The Commission has issued the enclosed Amendment No. to Provisional Operating License No. DPR-19 for Dresden Station Unit 2 and Amendment Nos. and to Facility Operating License Nos. DPR-29 and DPR-30 for Quad Cities Station Units 1 and 2, respectively. The amendments are in response to your letter of March 19, 1980.

The amendments establish MAPLHGR limits for standard 8x8 (8D250 and 8D262) fuel types for exposure values beyond those currently given in the Technical Specifications.

AMENDMENT TO PROVISIONAL OPERATING LICENSE

SAFETY EVALUATION BY THE OFFICE OF NUCLEAR REACTOR REGULATION
SUPPORTING AMENDMENT NO. 50 TO PROVISIONAL OPERATING LICENSE NO. DPR-19,
AMENDMENT NO. 59 TO FACILITY OPERATING LICENSE NO. DPR-29, AND
AMENDMENT NO. 54 TO FACILITY OPERATING LICENSE NO. DPR-30

FIGURE 3.5-1
(Sheet 1 of 4)

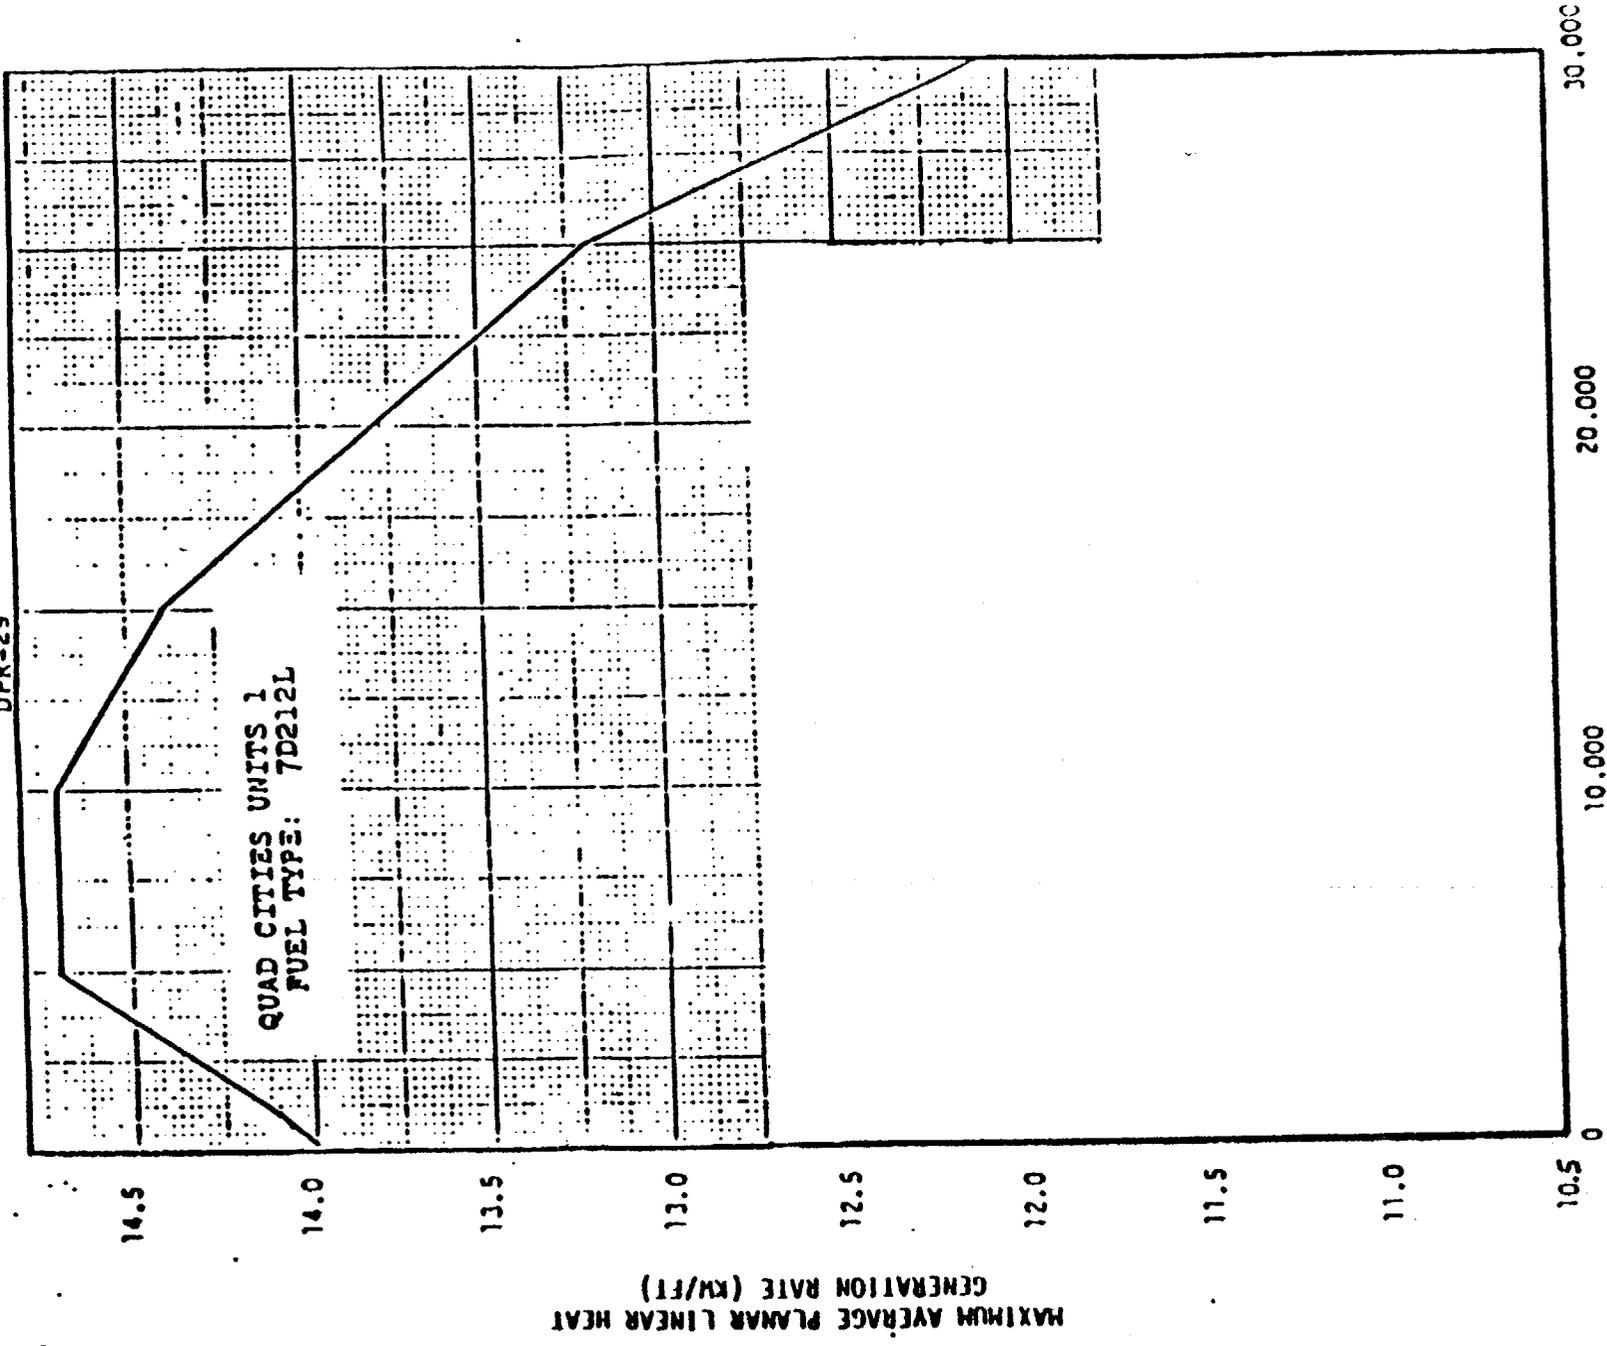
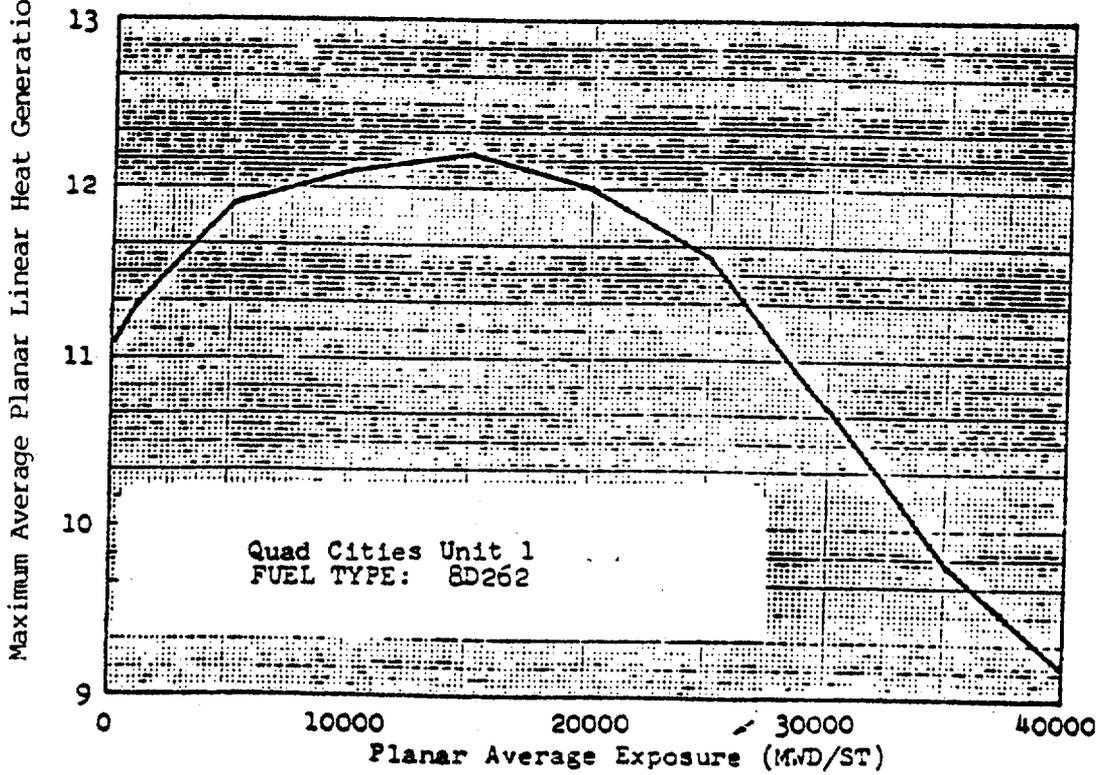
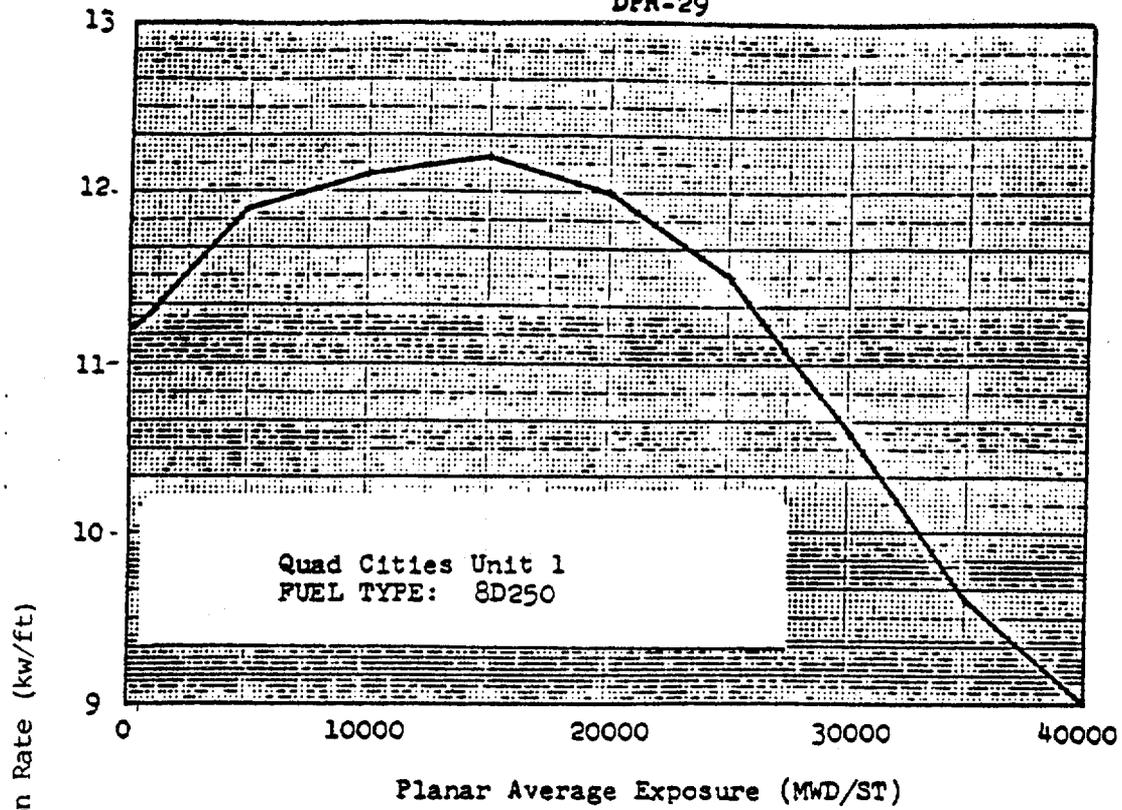
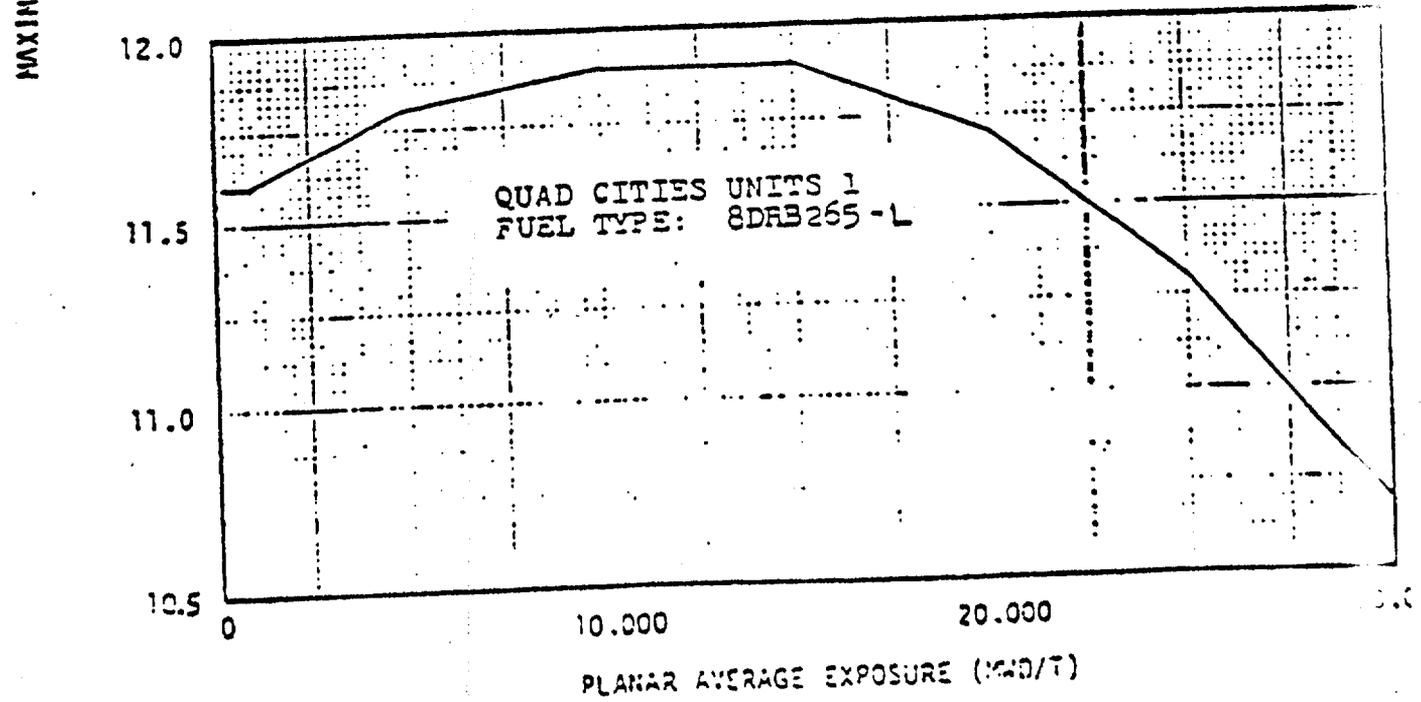
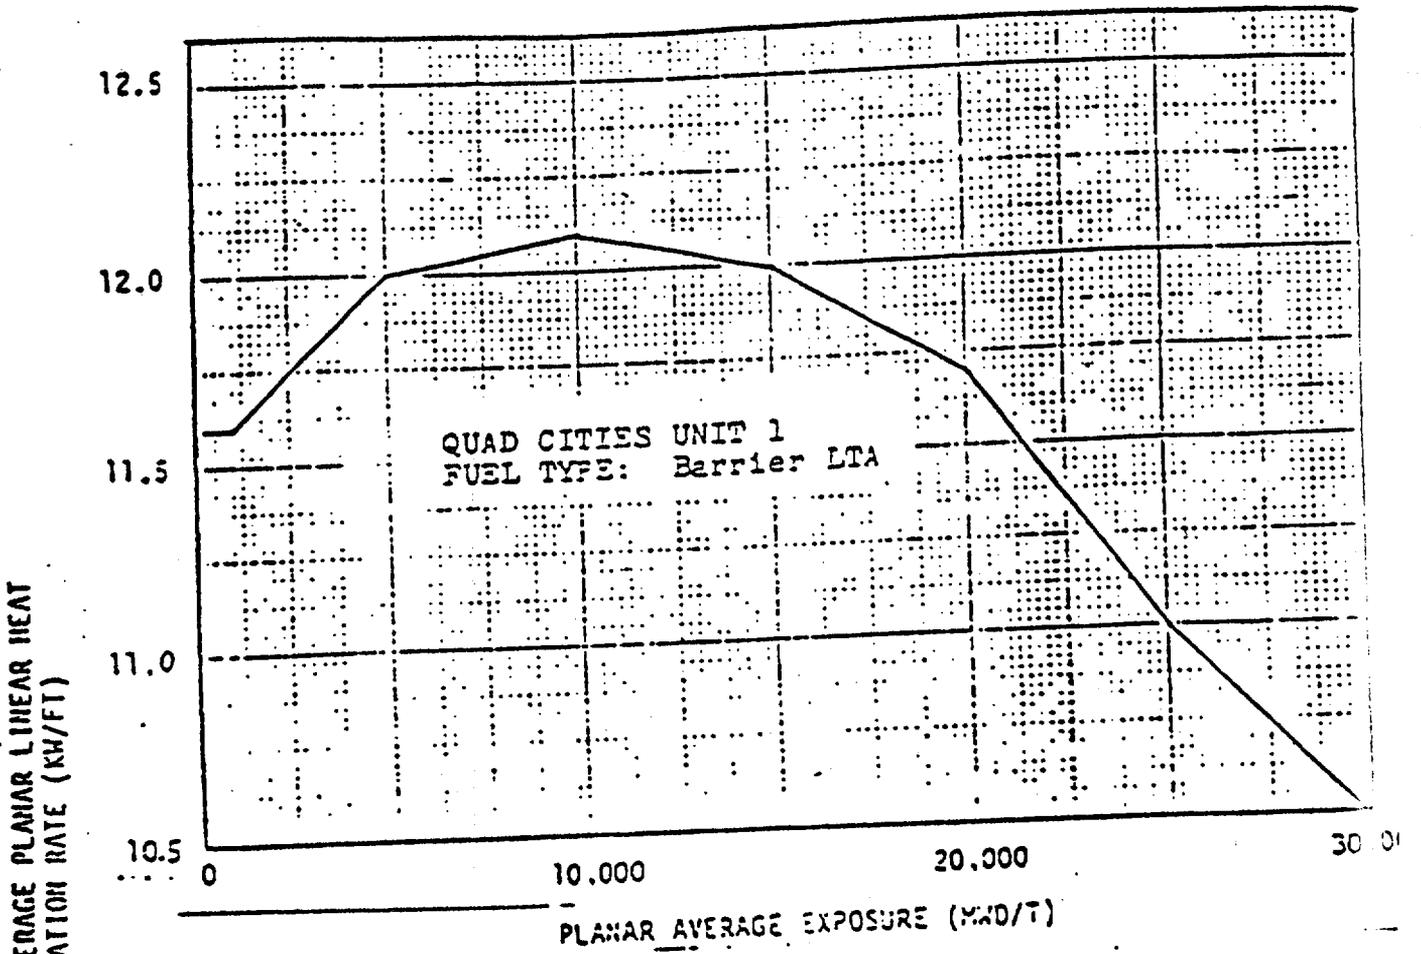
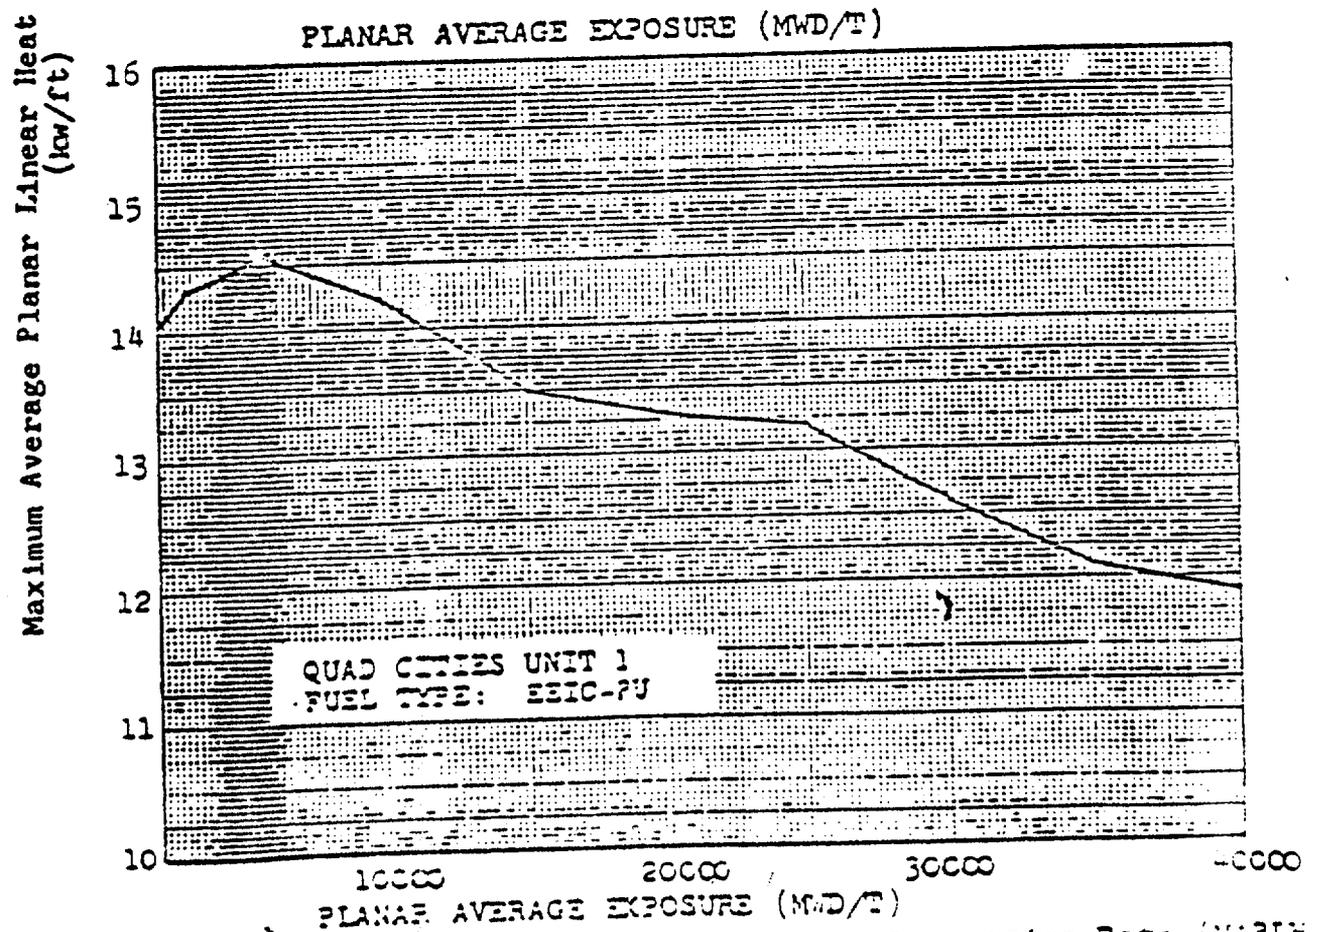
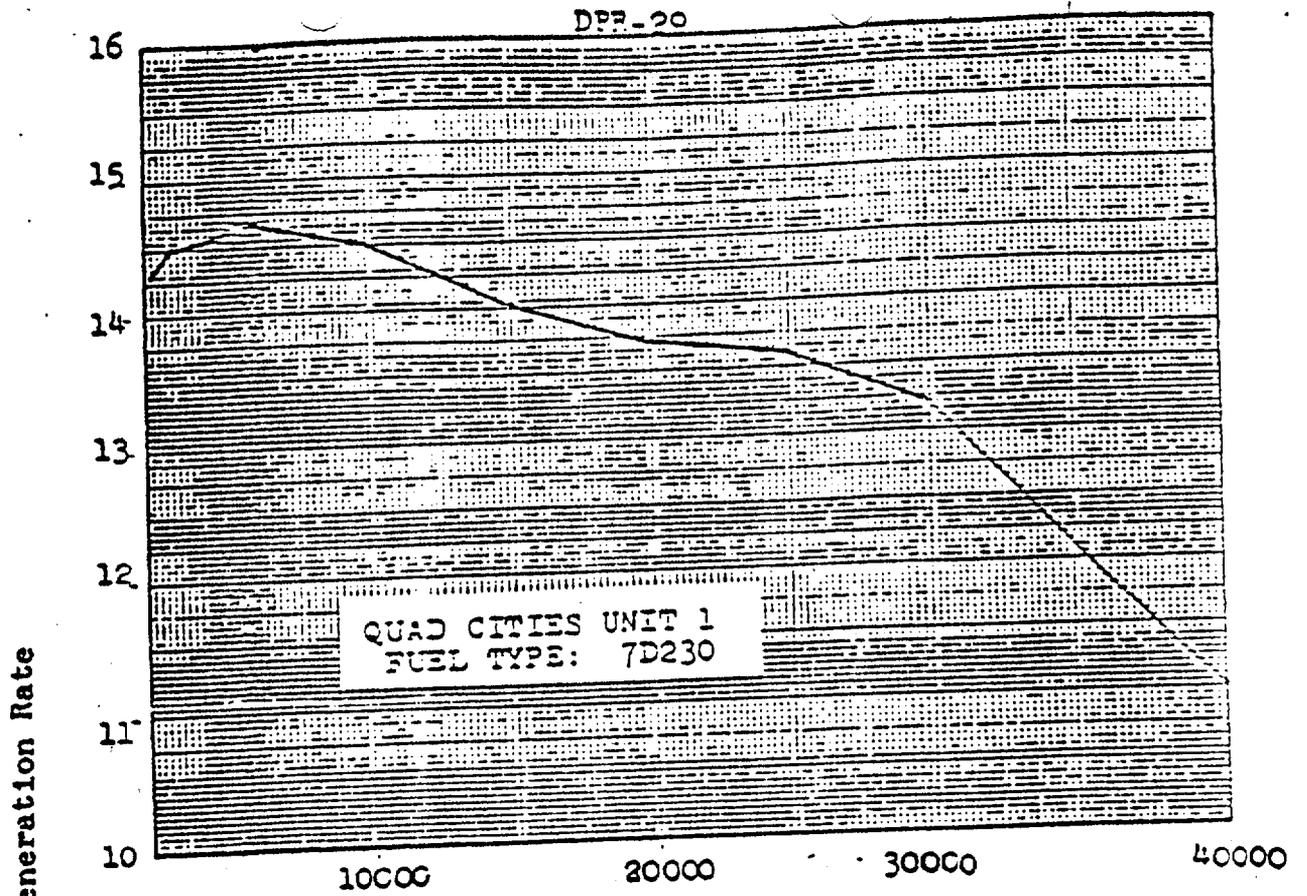
Revise the Appendix "A" Technical Specifications as follows:

3.5/4.5-9
Fig. 3.5-1 (Sheet 1 of 3)
Fig. 3.5-1 (Sheet 2 of 3)
Fig. 3.5-1 (Sheet 3 of 3)
--

3.5/4.5-9
Figure 3.5-1 (Sheet 1 of 4)
Figure 3.5-1 (Sheet 2 of 4)
Figure 3.5-1 (Sheet 3 of 4)
Figure 3.5-1 (Sheet 4 of 4)

During steady-state power operation, the average linear heat generation rate (APLHGR) of all the rods in any fuel assembly, as a function of average planar exposure, at any axial location, shall not exceed the maximum average planar LHGR shown in Figure 3.5-1.
